UNITED STATES PATENT AND TRADEMARK OFFICE

APPLICATION NO.	FILING DATE	FIRST NAMED INVENTOR	ATTORNEY DOCKET NO.	CONFIRMATION NO.
10/573,629	12/22/2006	Hubert Bischof	3651	5669
278	7590	11/30/2009		
MICHAEL J. STRIKER 103 EAST NECK ROAD HUNTINGTON, NY 11743			EXAMINER GONZALEZ QUINONES, JOSE A	
			ART UNIT 2834	PAPER NUMBER
			NOTIFICATION DATE 11/30/2009	DELIVERY MODE ELECTRONIC

Office Action Summary**Application No.**

DETAILED ACTION

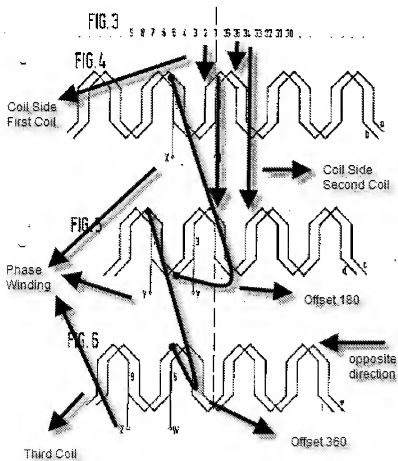
As to claim 1, Kreuzer teaches stator (115) of a three-phase generator, having a multi-strand stator winding, wherein each of the m phase windings (X, Y, Z) is comprised of a group, which has a first coil with coil sides (See annotation in figure 3-6), which are contained in grooves (2 and 35) that are spaced apart from one another by 180° electrically and the first coil has a particular number of turns (Zw), has a second coil with coil sides (See annotation in figure 3-6), which are contained in grooves (1 and

34) that are spaced apart from one another by 180° electrically and the second coil has a particular number of turns (z_w), the second coil is offset from the first coil in a first direction by $180^\circ/m$ ($M=3$) electrically, and in accordance with the predetermined number of pole pairs, a corresponding number of groups that are offset from one another by 360° electrically are arranged one after another in the stator (115) as shown in figure 3-6. (See figure 3-6 below)

As to claim 2, Kreuzer teaches wherein the group also has a third coil that precedes the first coil by $180^\circ/m$ electrically in a second direction opposite from the first offset direction as shown in figure 3-6. (See figure 3-6 above)

As to claim 4, Kreuzer teaches wherein the phase windings (X, Y, and Z) are comprised of multi-strand wire as shown in figure 3-6. (See figure 3-6 above)

As to claim 7, Kreuzer teaches wherein it is the stator (115) of a machine with three phase windings (X, Y, Z), in particular a three-phase generator as shown in figure 3-6. (See figure 3-6 above)
